# Wisconsin Department of Transportation

**Proposal #23: 1000-20-75, WISC 2017 133  
 Statewide Type I Sign Replacement  
 Locations on STN per Annual Plan  
 Various Highways  
 Statewide**

**Letting of February 14, 2017**

This is Addendum No. 01, which provides for the following:

Addendum No. 01  
ID 1000-20-75  
Added Sheet 64A  
February 2, 2017

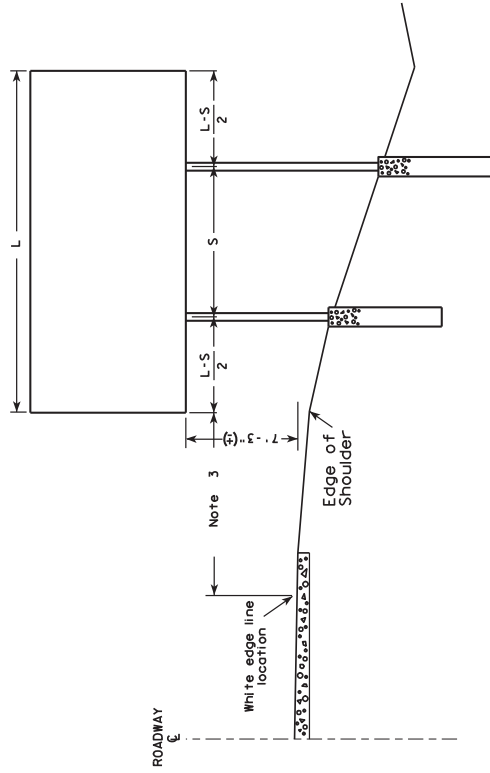
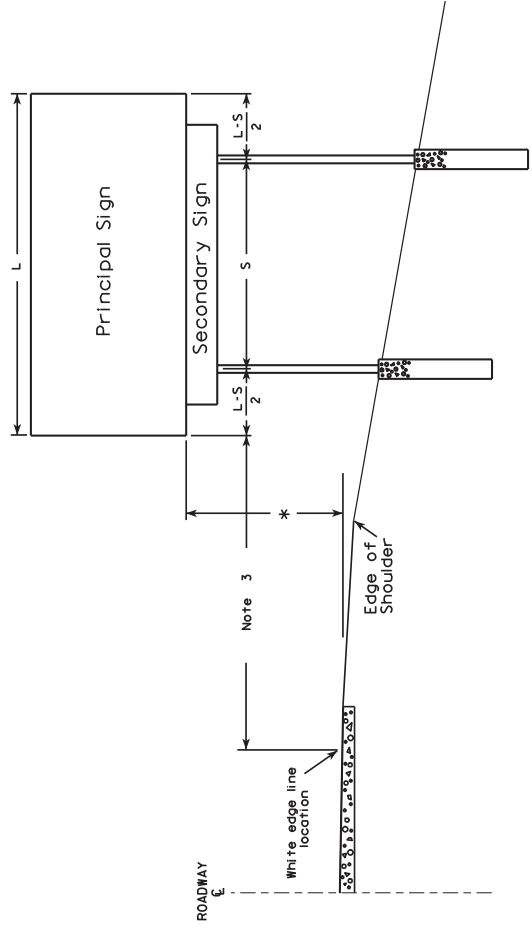
<b>Added Plan Sheets</b>	
<b>Plan Sheet</b>	<b>Plan Sheet Title (brief description of why sheet was added)</b>
64A	Sign Plate A4-1 – Typical Installation of Type I Signs (sheet needed to show mounting height and offset of type I signs in order for the contractor to correctly field identity beam lengths needed)
